INLAND WETLANDS AND WATERCOURSES COMMISSION

**AGENDA  
JANUARY 13, 2026**

Application 25-25 15 Plum Tree LLC-Permit approval to construct a 3 story apartment building & 9 attached townhouses, a retaining wall, subsurface stormwater detention system, level spreader, sidewalks and storm drainage within a regulated area at 5 & 15 Plumtree Lane.

# MILL RIVER PARK 5 & 15 PLUMTREE LANE TRUMBULL & EASTON, CONNECTICUT

**Sheet 2.2 (Mislabeled as 2.1) – Underground Utilities Plan:**

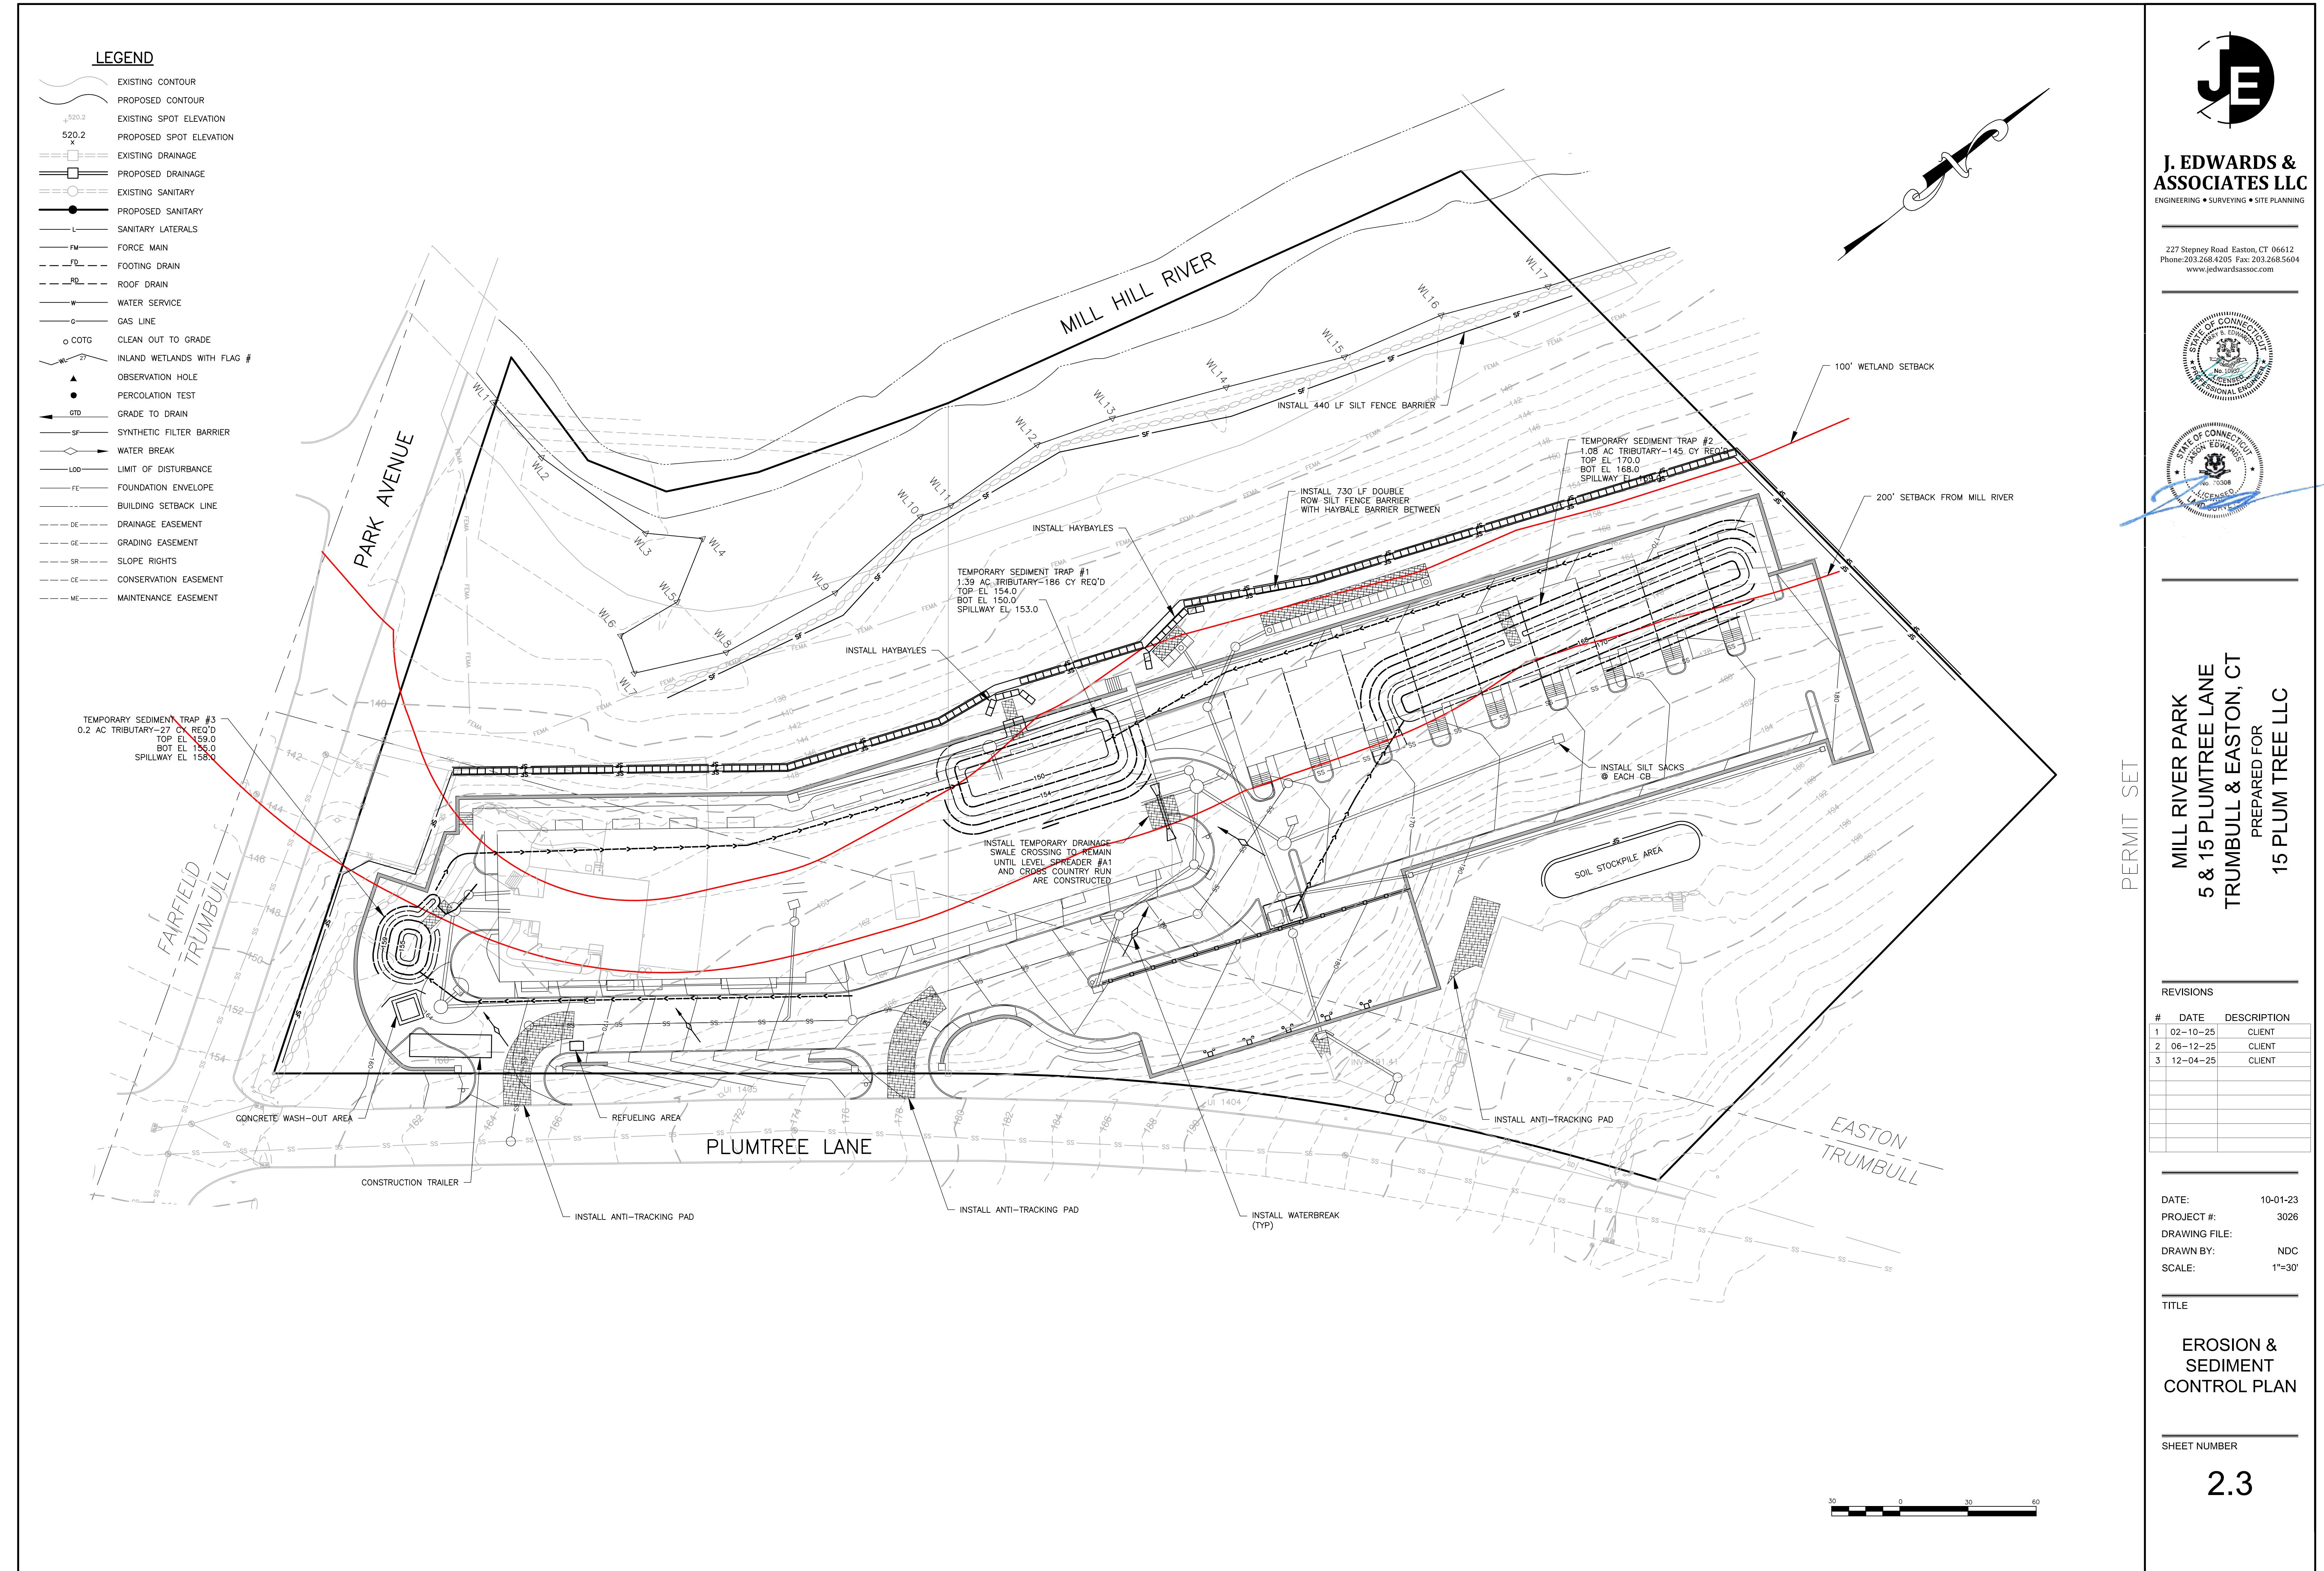
- 12)** The property's ability to handle water onsite will be altered by the removal of mature trees which, by way of their roots, take up water for metabolic processes. The Applicant should explain how the proposed plan will compensate or mitigate for this change.
- 13)** Note 18 says disturbance will be limited to 1 acre at any time. Note 13 says Approximately 2.1 acres will be disturbed. This indicates that the project is to be phased, but no phasing is noted. Application should reconcile these notes
- 14)** The Underground Utilities Plan is labeled as Sheet 2.1 when it appears it should be labeled as 2.2. This should be corrected for clarity.

Sheet 2.1 (underground utility plan):
